date: October 28, 2024
to: James Murphy, Assistant Director of Planning, Zoning and Building, Town of Palm Beach
from: Eric Czerniejewski, P.E., ENV SP
subject: Palm Beach Synagogue Traffic Review

MEMORANDUM

The Corradino Group, Inc (Corradino) has been requested to provide a traffic review of the Traffic Impact Statement for the Palm Beach Synagogue redevelopment located at 120 and 132 North County Road in the Town of Palm Beach, Florida. The following are our traffic review comments based on the 09/23/24 resubmittal.

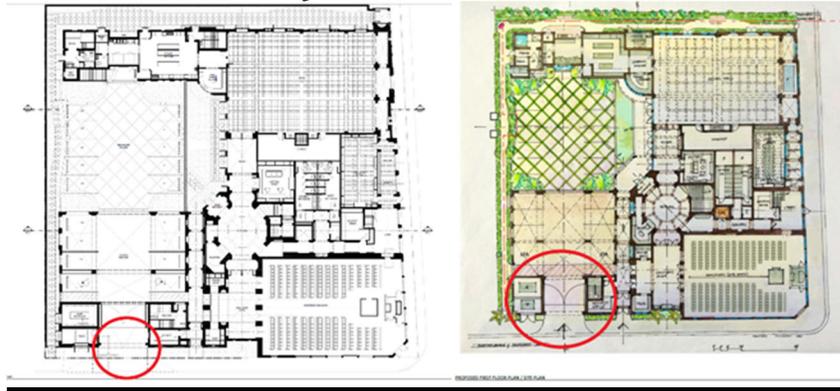
6. Please provide a 95th Percentile Vehicle Queueing Analysis Section in the updated Traffic Impact Statement. This Section should include a table that summarizes the 95th percentile vehicle queues for the key turn lanes at the signalized intersections. The table should include the existing turn lane storage and the 95th percentile vehicle queues at all key turn lanes at signalized intersections for each scenario. Please provide a narrative and report out any turn lanes where the 95th percentile vehicle queue extends past the available storage length.

Simmons & White's 09/23/24 Response: A 95th percentile queue analysis has now been provided. See Section 7.0 and Tables 12-14 in the revised traffic study.

TCG 10/28/24 Response: Addressed.

OROURKE 24174.01.03 Bradley Place and Sunset Avenue Proposed Control Configuration Figure 6

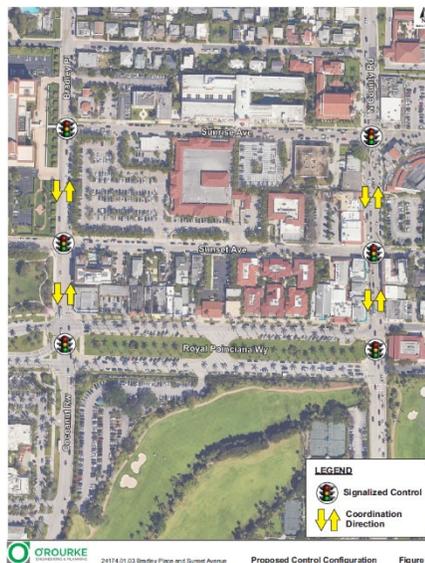
9. Please update the intersection capacity analysis for the future with the project scenario at the Bradley Place and Sunset Avenue intersection. A traffic signal warrant analysis was completed, and a traffic signal was deemed warranted at this current stop-controlled intersection. Please include an analysis of this intersection as a full signalized intersection.

Simmons & White's 09/23/24 Response: An analysis has now been completed for this intersection assuming full signal control for both the background and total traffic scenarios. See Section 6.0 (Intersection Analysis) and Tables 10-11.

TCG 10/28/24 Response: Addressed.

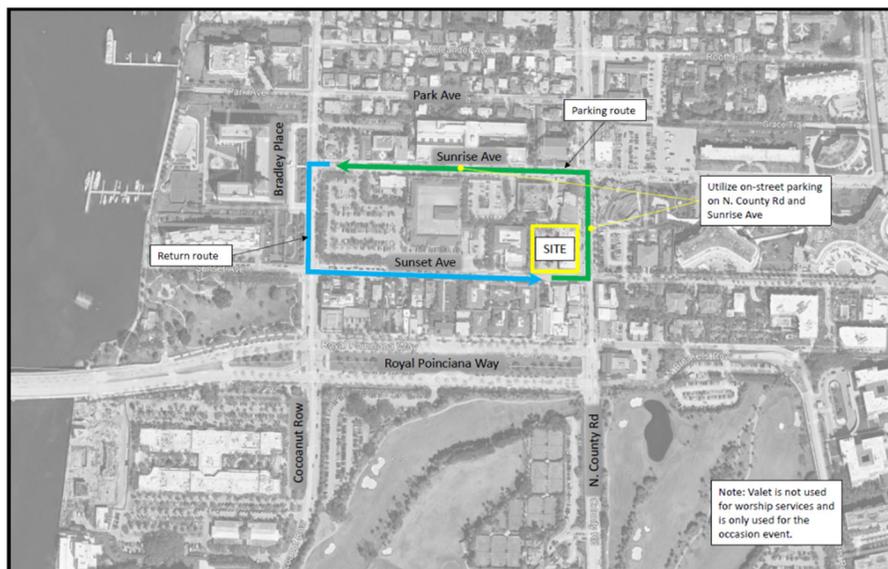
11. Please provide a parking study for the proposed redevelopment that addresses the Principle of Equivalency per Code Section 134-2175 (d). Please provide a Site Plan sheet that includes the number of parking spaces required per the Town of Palm Beach code and the number of spaces being proposed. Please confirm if special events will be held at the Synagogue and discuss the proposed parking plan for these events.

Simmons & White's 09/23/24 Response: A parking analysis is provided in Section 11.0 of the traffic study but a separate Parking Study has now been provided as well.
